**PROJECT:
PROPOSED ALTERATIONS
& ADDITIONS**

SITE:
84 PITT ST, SYDNEY
CLIENT:
SP50723

On behalf of the Owners SP50723, please find attached amended plans by DRE Design numbered DA00-DA08 Revision F Dated 20 July 2021.

This letter has been prepared on behalf of DRE Design Pty Ltd to accompany amended plans and details that relate to the above development application. The amended plans include design changes to address the risk of flooding at 84 Pitt Street (the **site**).

SELECTED ARCHITECTURAL DRAWINGS

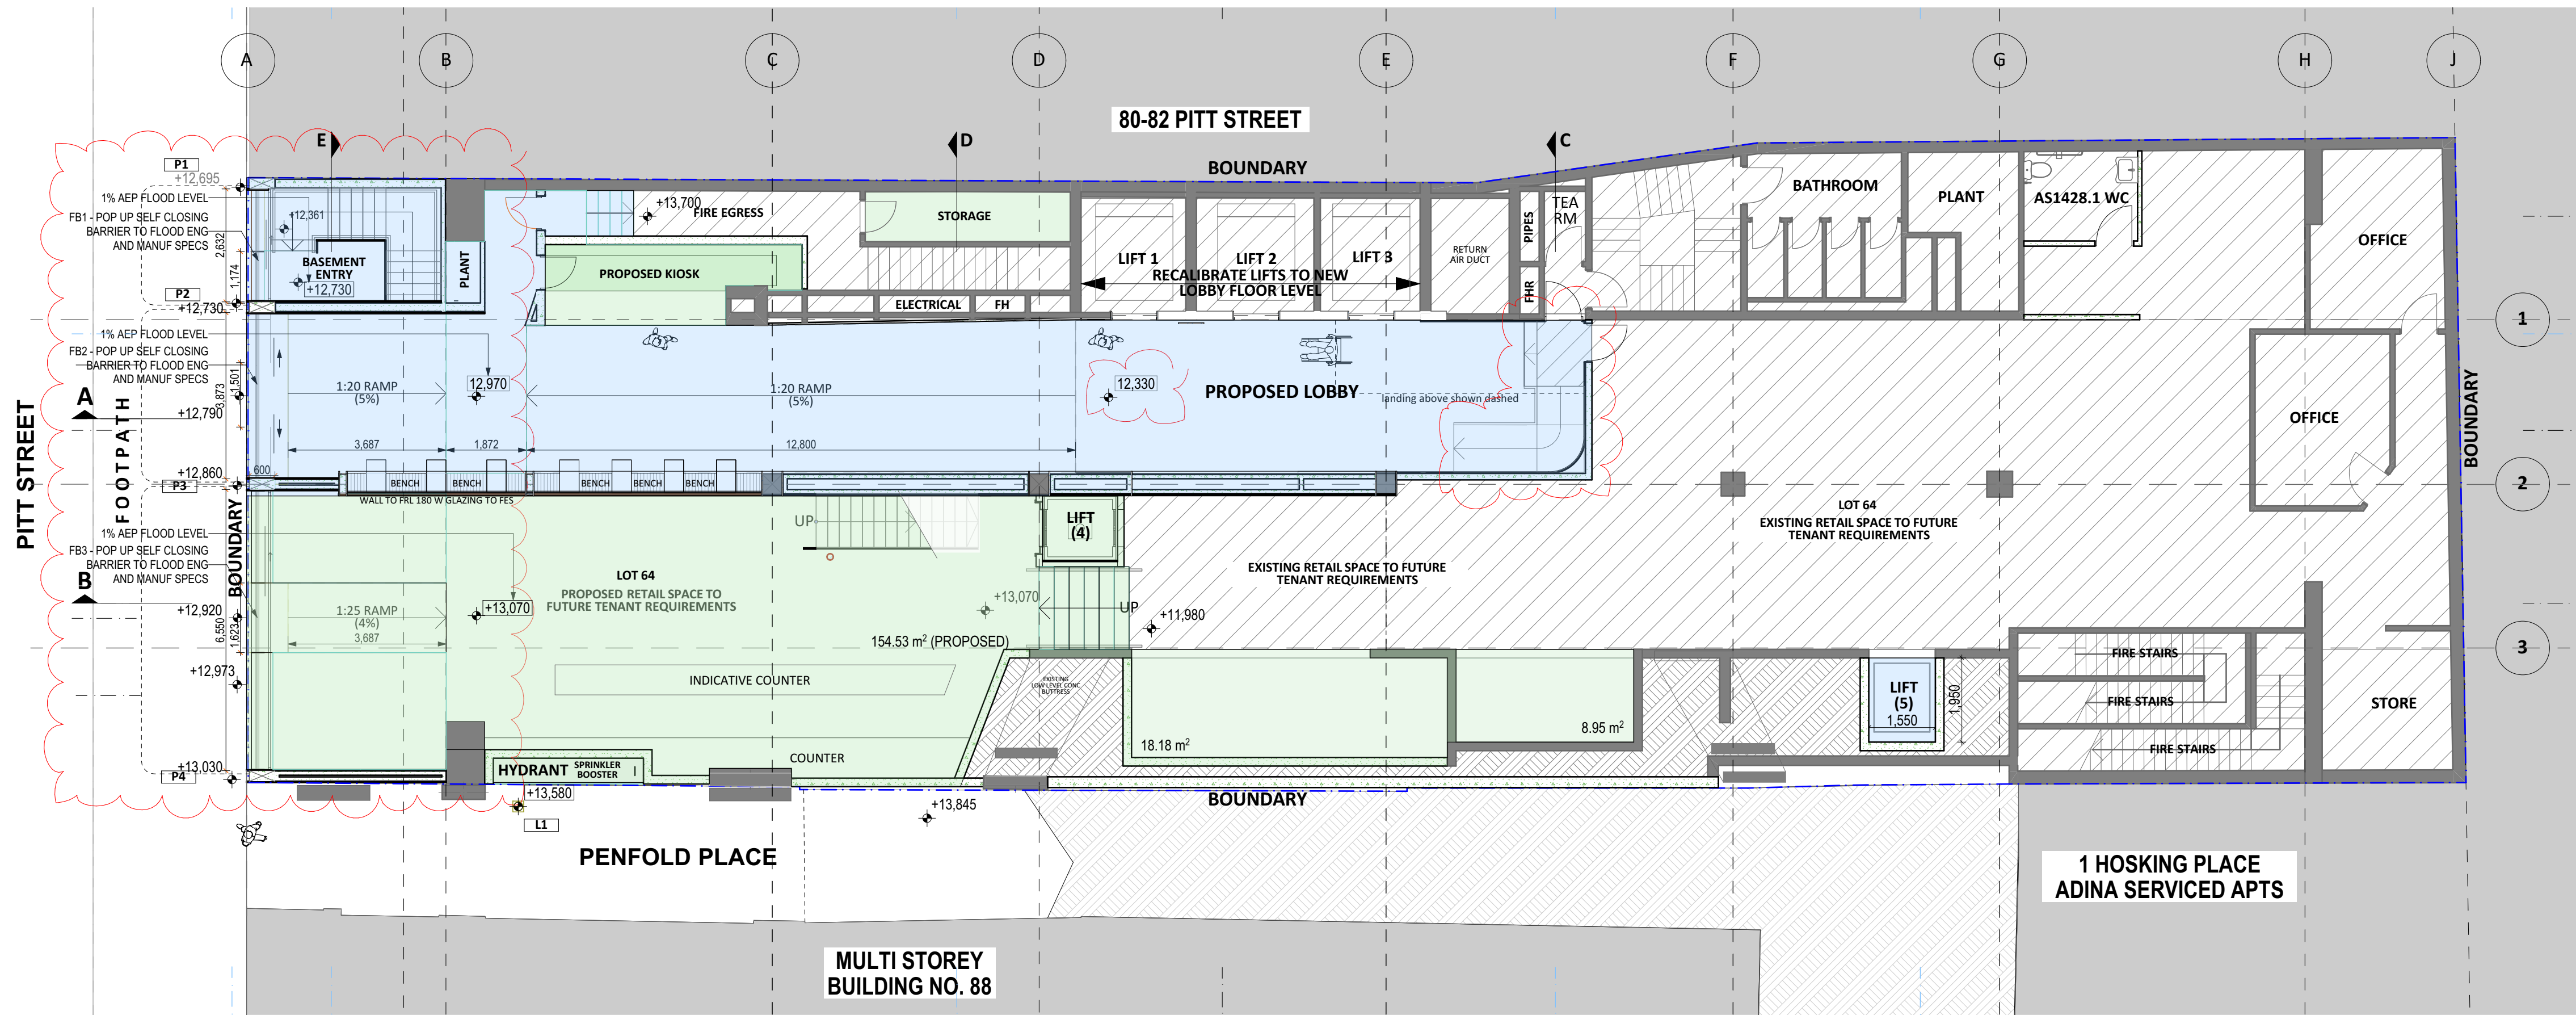
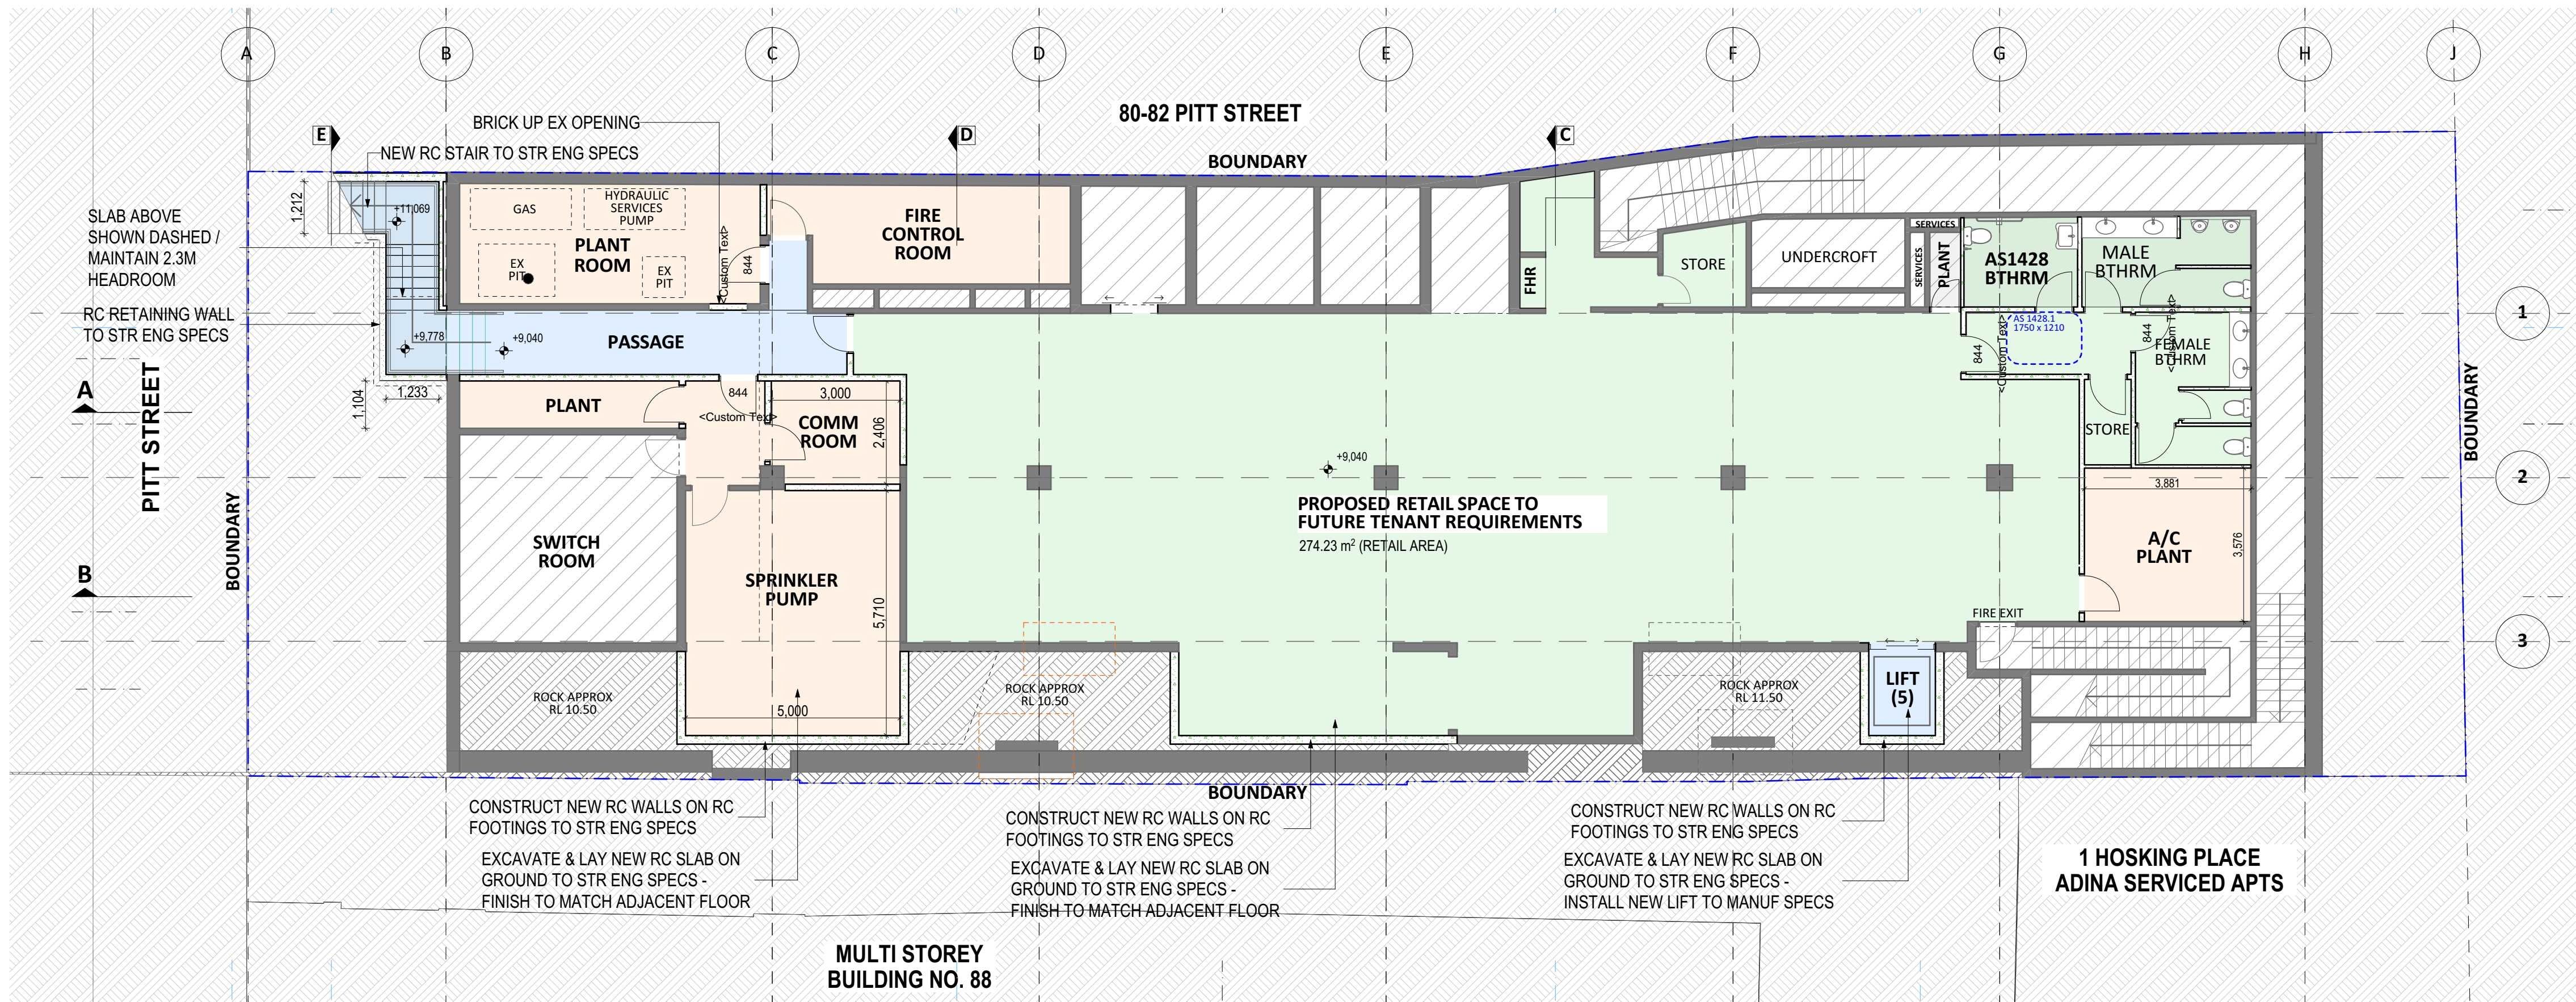
The amended architectural plans respond to the Flood Advice and incorporate changes to the ramp grade to the main commercial lobby to increase the finished floor level height at the entry threshold and the lift lobby; introducing a slight ramp at the entrance to the proposed retail space (lot 64) to increase the finished floor level of this retail tenancy; and the incorporation of three self-closing flood barriers.

DRAWING TITLE :
FLOOD MITIGATION DETAILS

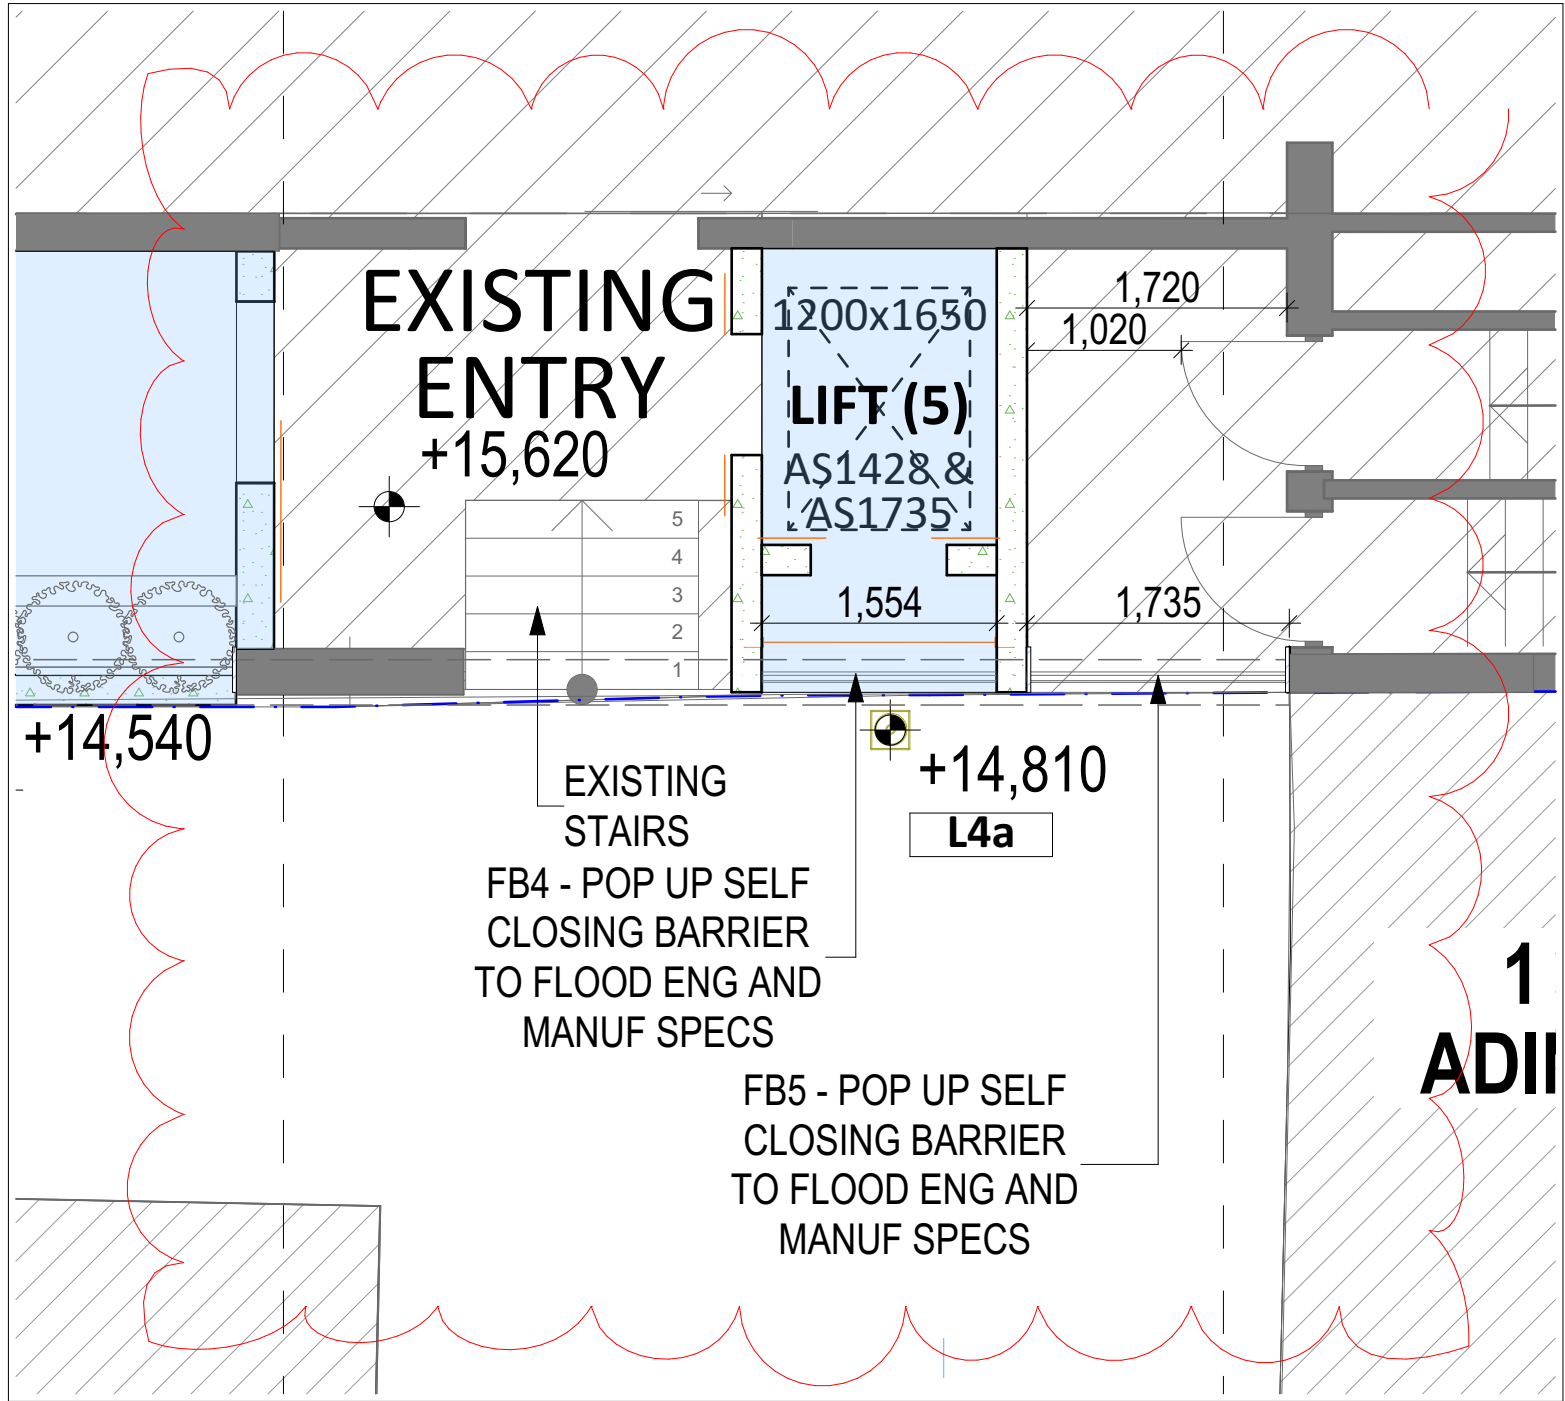
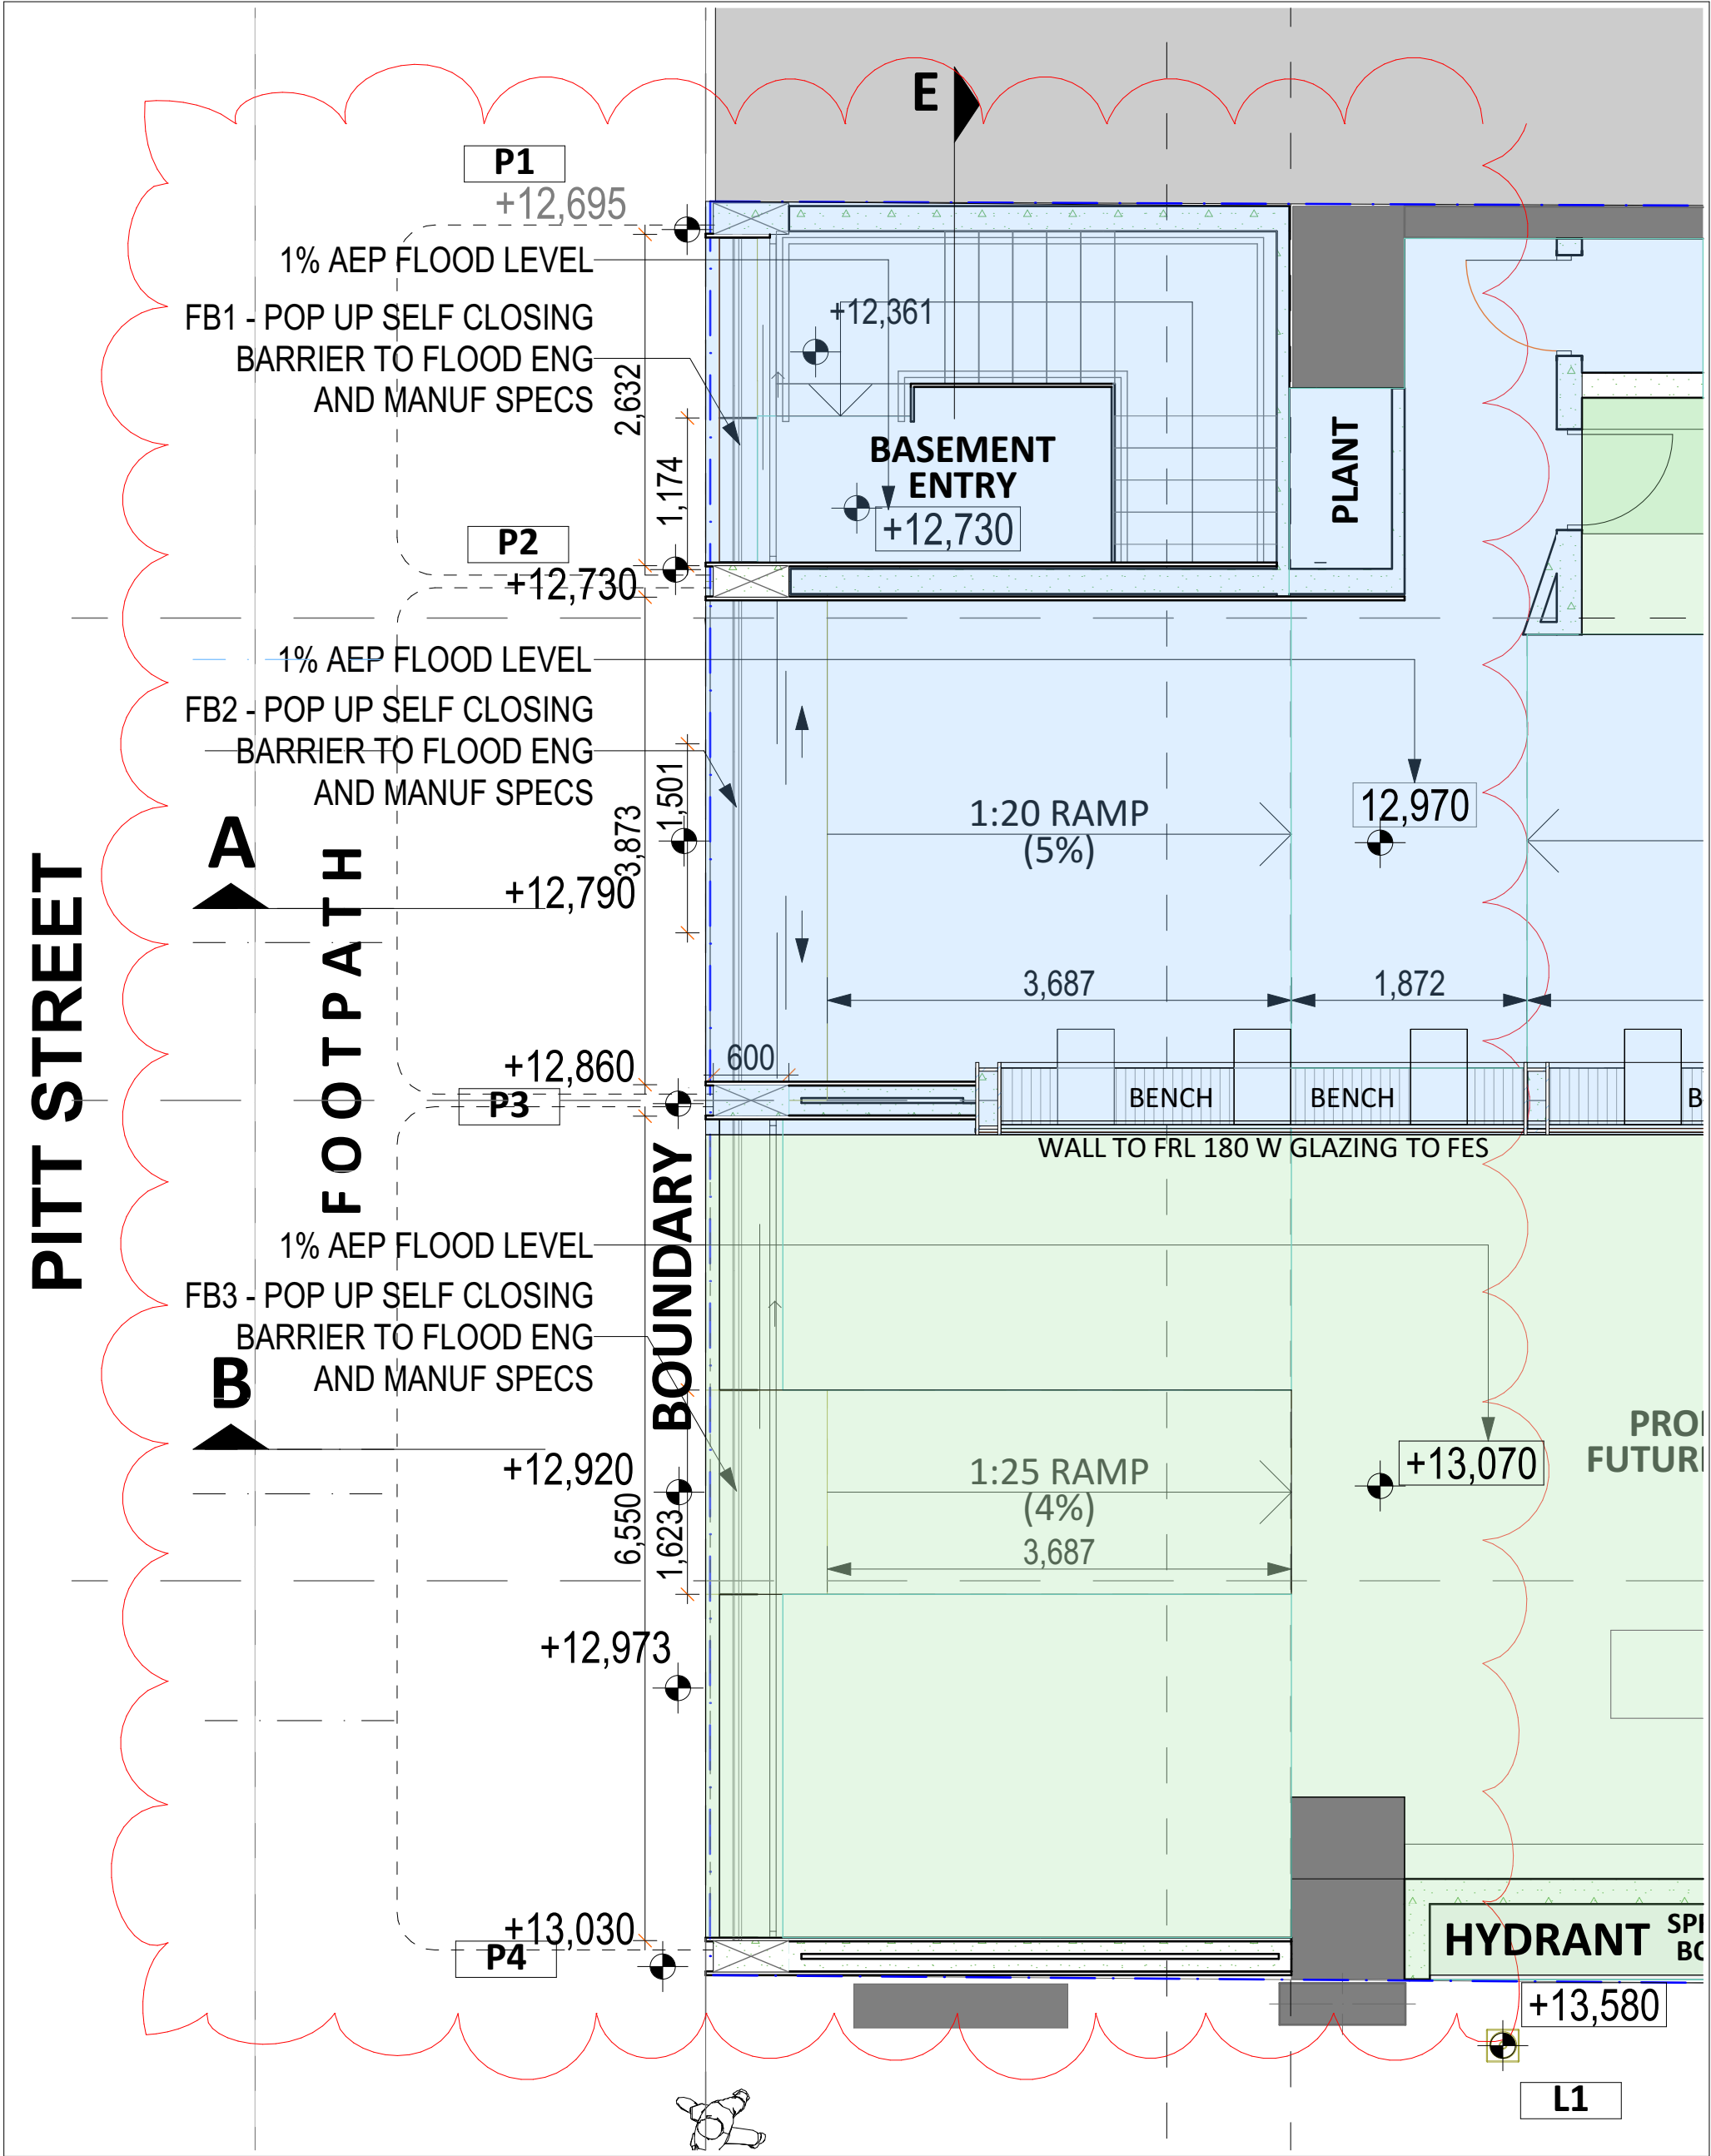
The installation of self-actuating flood barriers FB1 and FB4 and of flood door FB5 together protect the basement from the ingress of any floodwaters but also serve to protect the lower ground floor and Lot 64 against floodwaters outflanking the adopted flood protection measures.
